September 6, 2022

Subject: Sudbury-Hudson Transmission Reliability and Massachusetts Central Rail Trail Project (DEP File # 301-1287) OOC Issued 02/04/2021 Notification of Minor Change and Request for Administrative Approval

Attached please find three plan sheets showing the proposed minor change that upon administrative approval would replace the corresponding sheets in the plan set previously approved by the Commission.

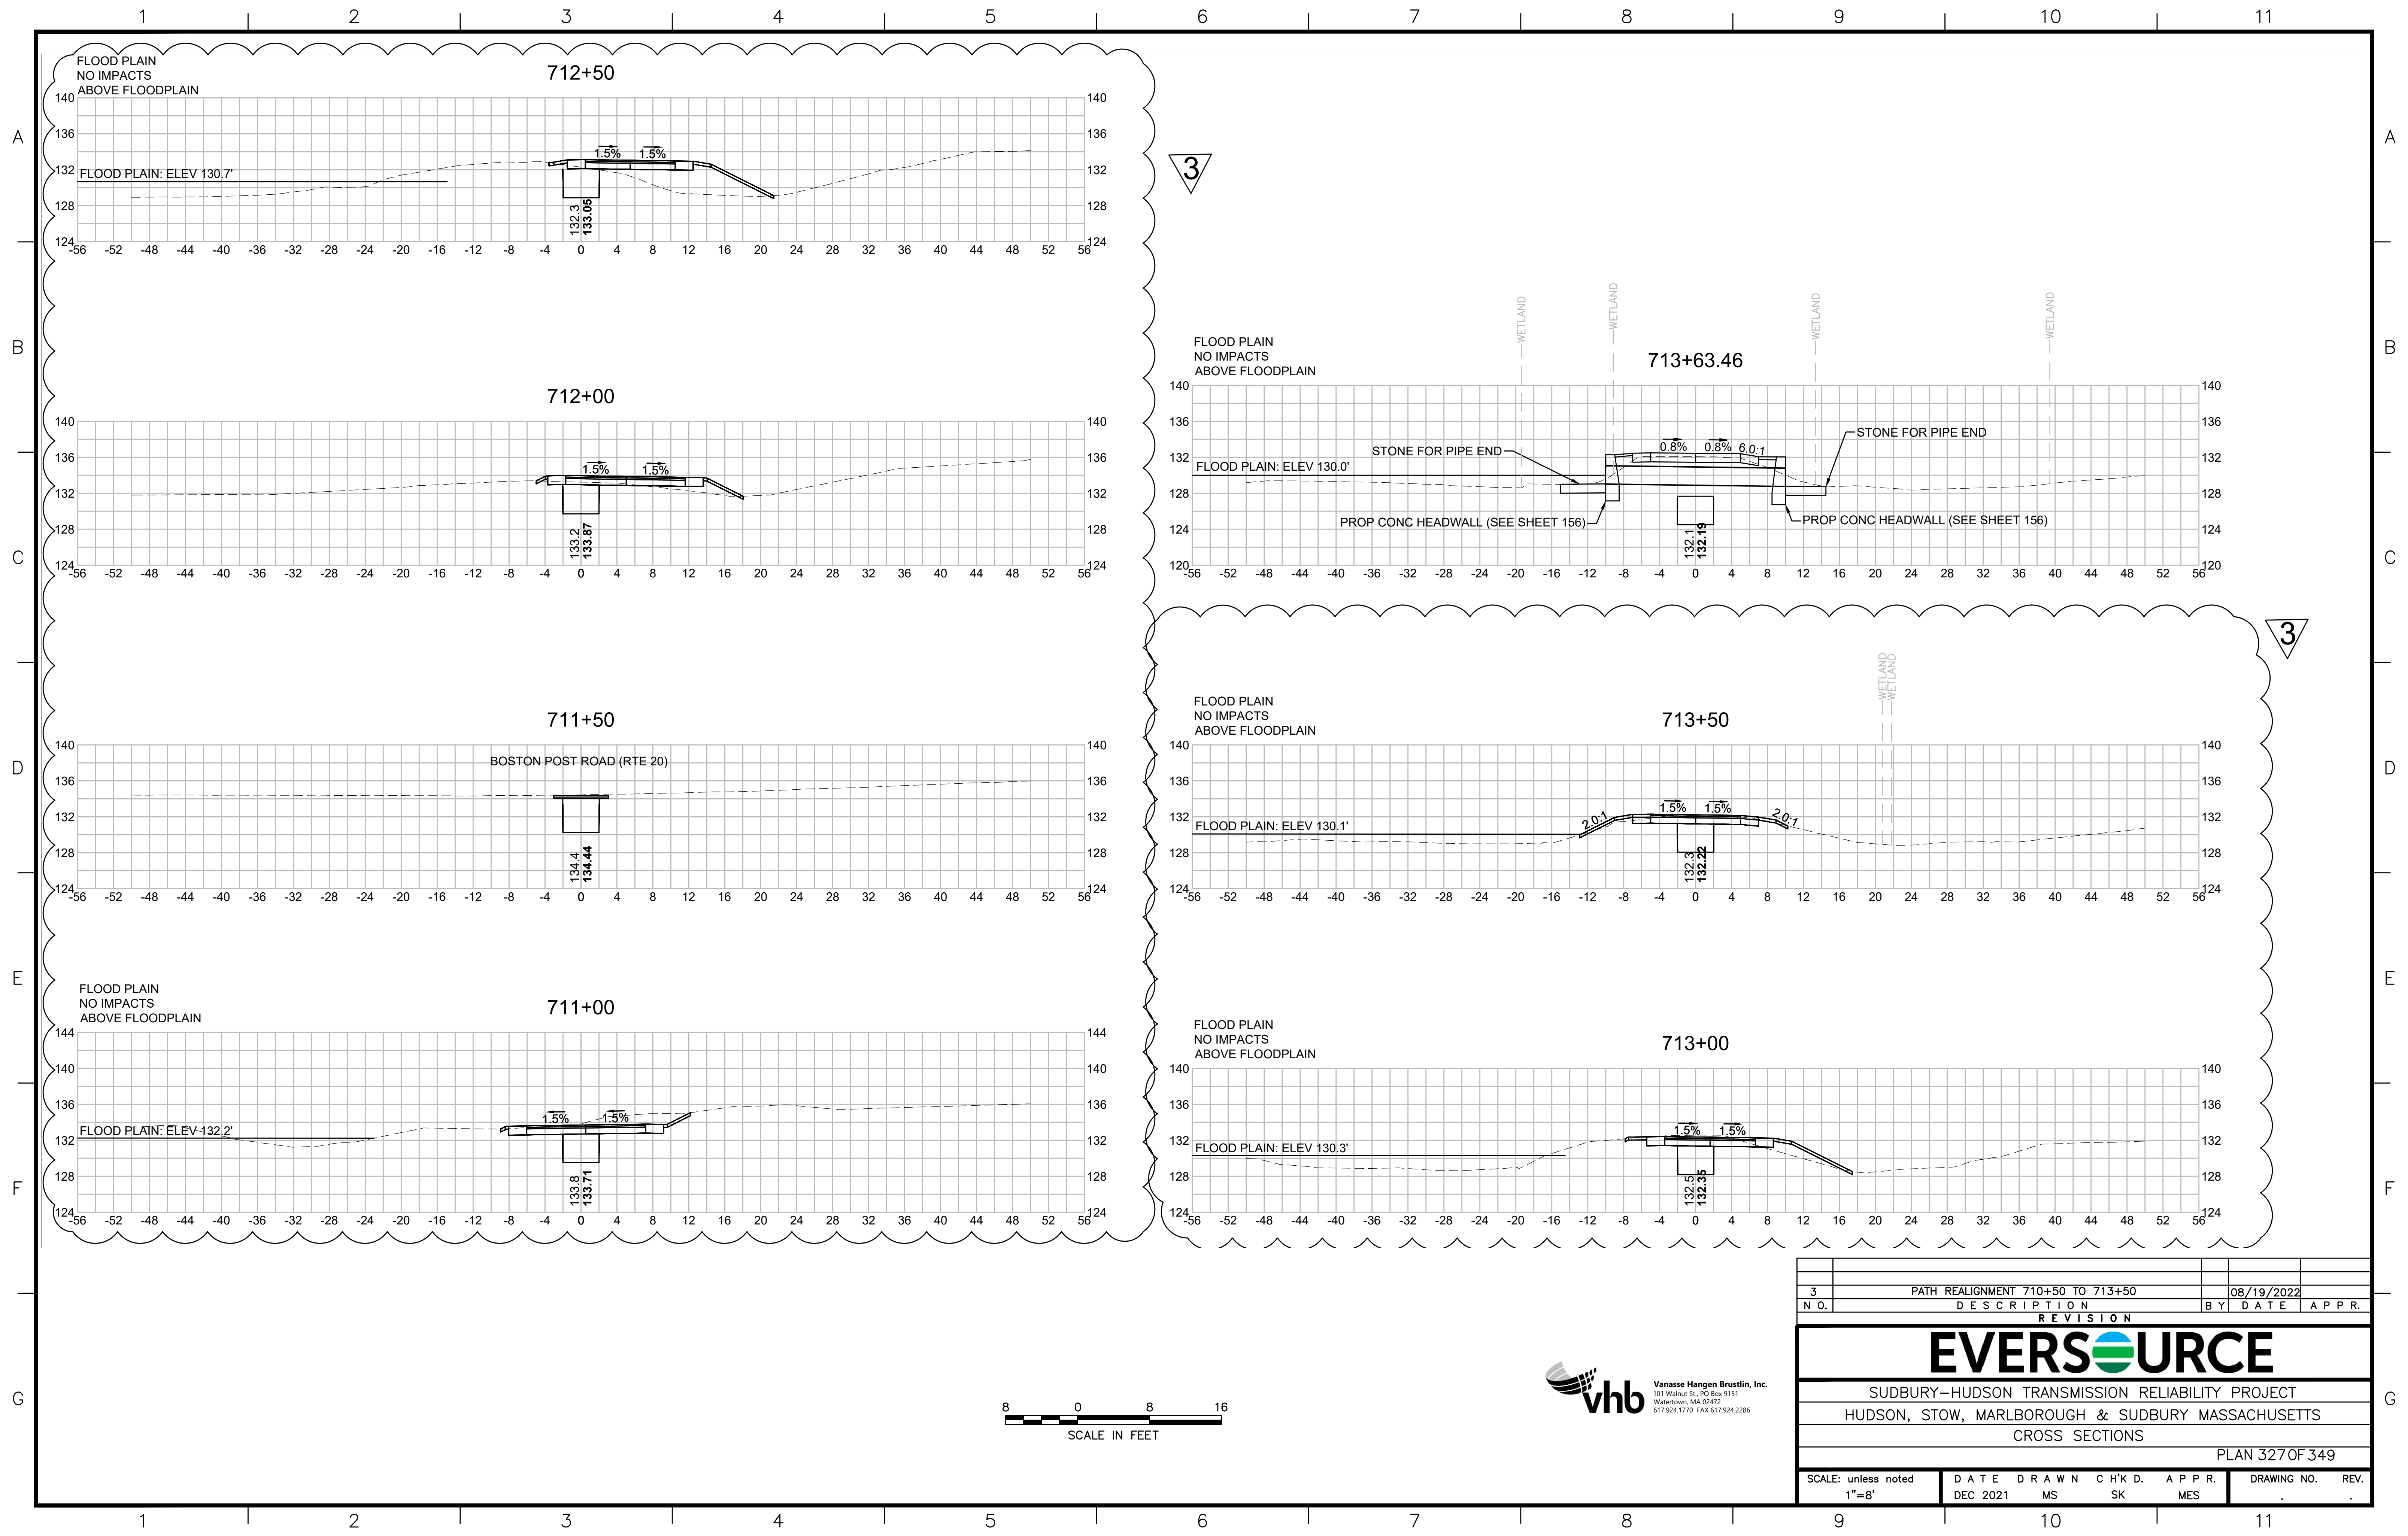
3		PATH REALIGNMENT 710+50 TO 713+50		08/19/2022	
N O.	DESCRIPTION	BY	DATE	APPR.	
REVISION					
EVERSOURCE					
SUDBURY-HUDSON TRANSMISSION RELIABILITY PROJECT					
HUDSON, STOW, MARLBOROUGH & SUDBURY MASSACHUSETTS					
CROSS SECTIONS					
PLAN 327 OF 349					
SCALE: unless noted 1"=8'	DATE DEC 2021	DRAWN MS	CHK'D. SK	APPR. MES	DRAWING NO. REV.
